RUSSIAN FEDERATION
MINISTRY OF TRANSPORT OF THE RUSSIAN FEDERATION
FEDERAL AIR TRANSPORT AGENCY
AIRWORTHINESS DIRECTIVE

No. 2022-AHCAT-CK-09

Applicability – ANSAT helicopters (ANSAT-GC model)

TECHNICAL DECISION No. 5/144-2022-KB3
on continued airworthiness of the ANSAT helicopters (ANSAT-GC model)

**Fig. 1 Installation of fuel tanks
in the ANSAT helicopter (ANSAT-GC model)**

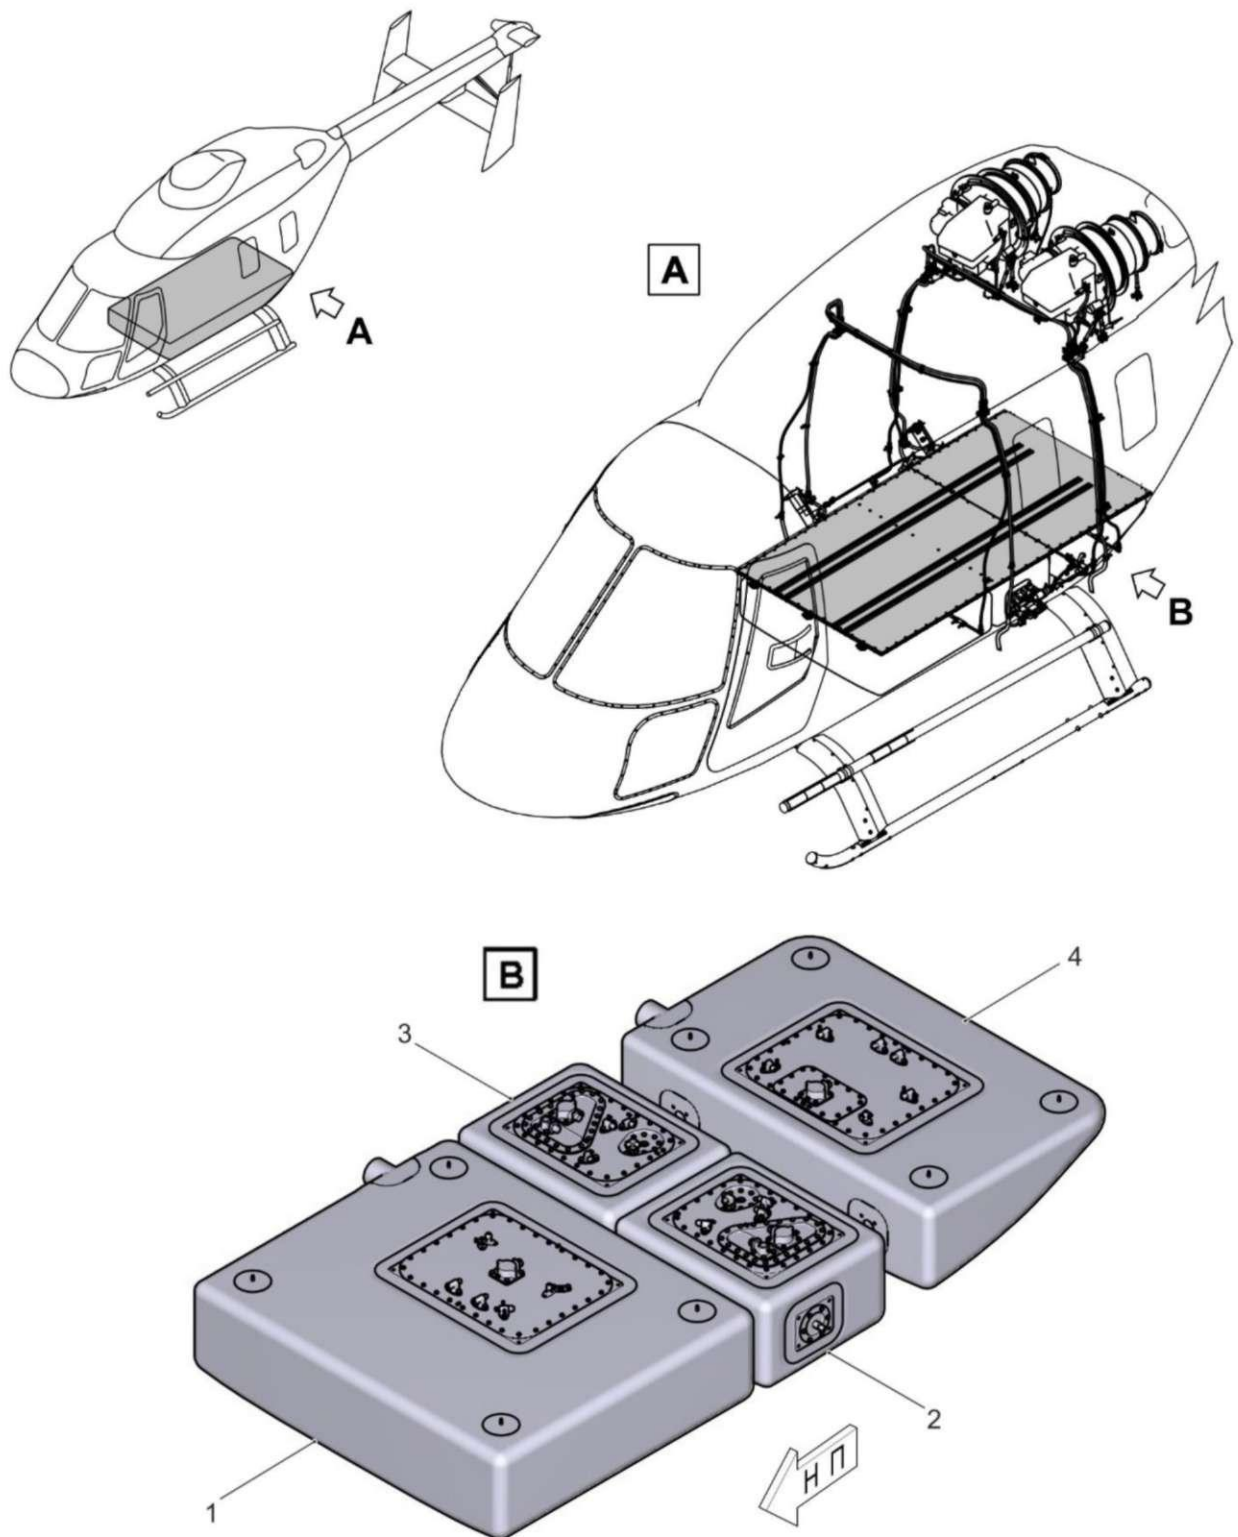
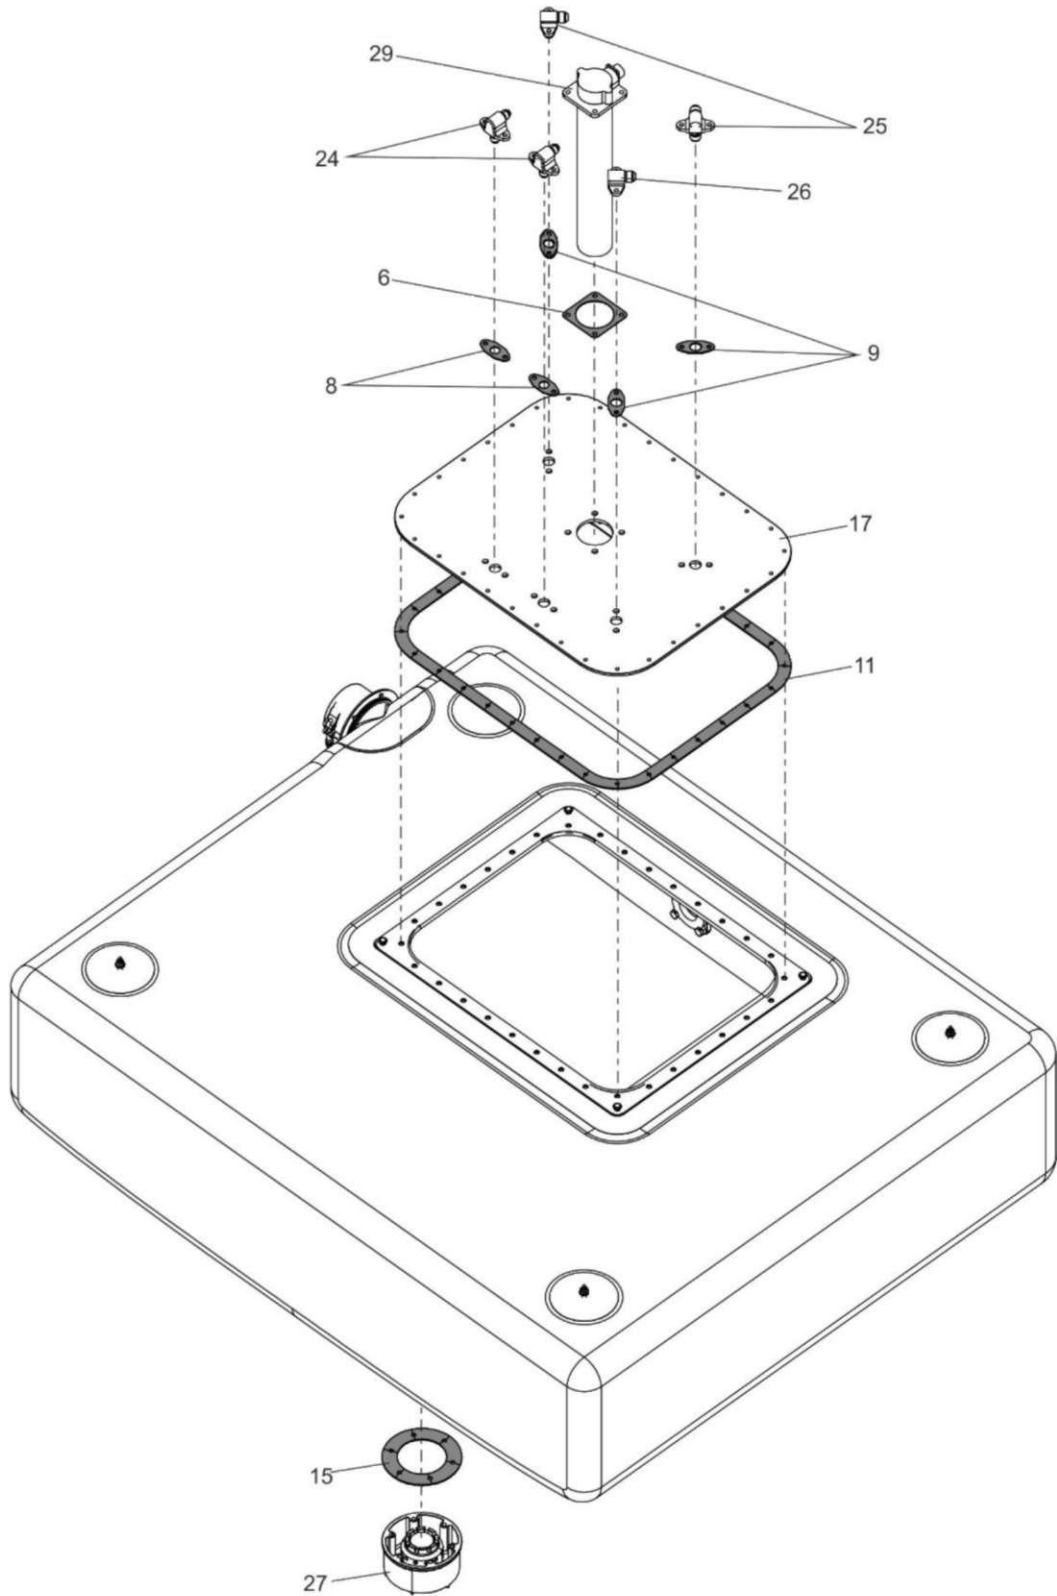
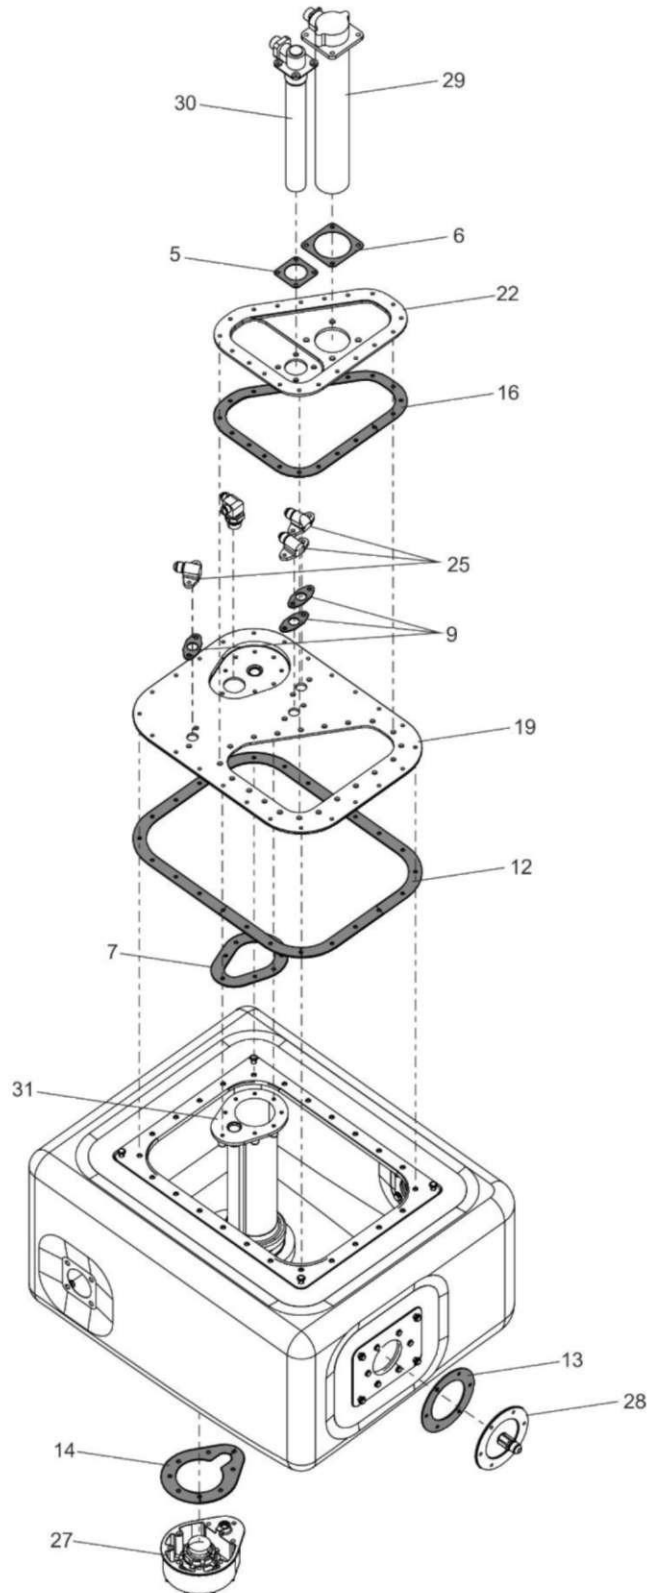
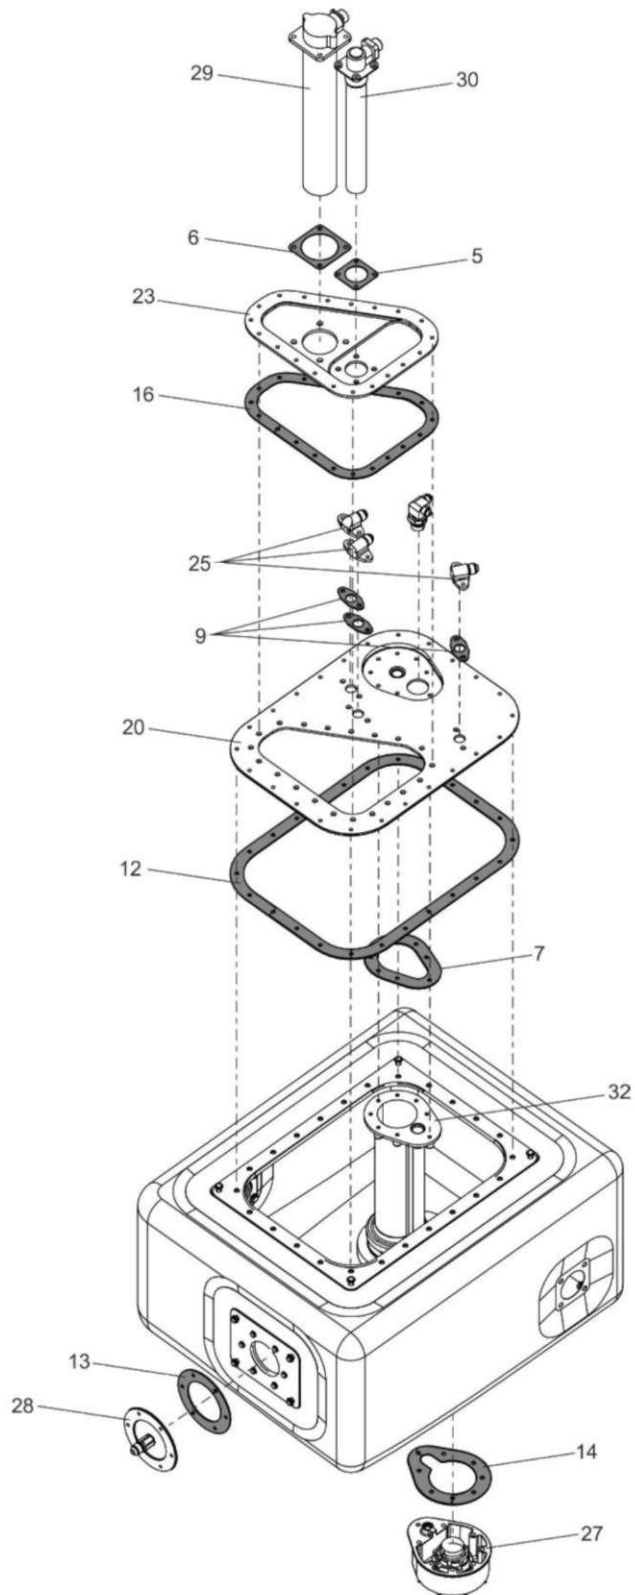
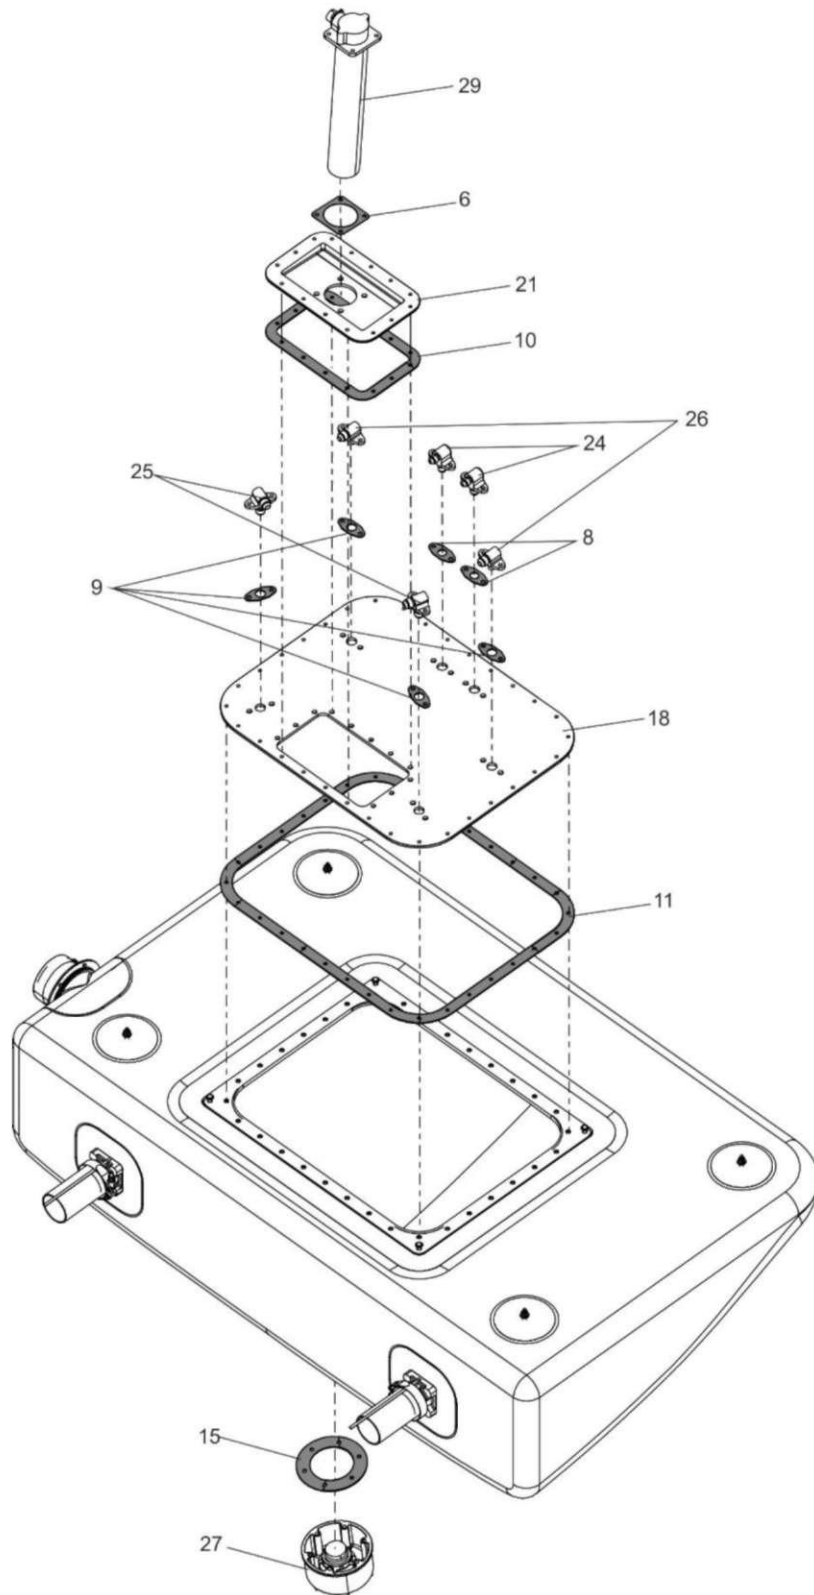
- 2.3 Inspect the rubber gaskets installed in fuel tanks (see Appendix 1) for presence of delamination, cracks, chipping;
 - 2.4 Inspect the inner cavities of all fuel tanks for presence of rubber particles (products of rubber gaskets disruption);

- 2.3, 2.4 – perform operations on fuel system cleaning in accordance with the temporary task card 028.10.00e (Appendix 2).
- 2.6 Replace the rubber gaskets (see pos. 5-16 of Appendix 1) with new ones. Replaceable rubber gaskets will be provided by JSC “Kazan Helicopters” at its own expense;

- 2.7 Perform installation of fuel system components earlier removed in accordance with p. 2.2 according to task card 028.10.00d. Install in place the angle pieces of pipelines connection to the plates of fuel tanks, having screwed the attaching screws with the torque $M=4.4+0.5Nm$ ($0.45+0.05$ kgf m), lock the screws in accordance with standard 4.5 OCT 1 39502-77;
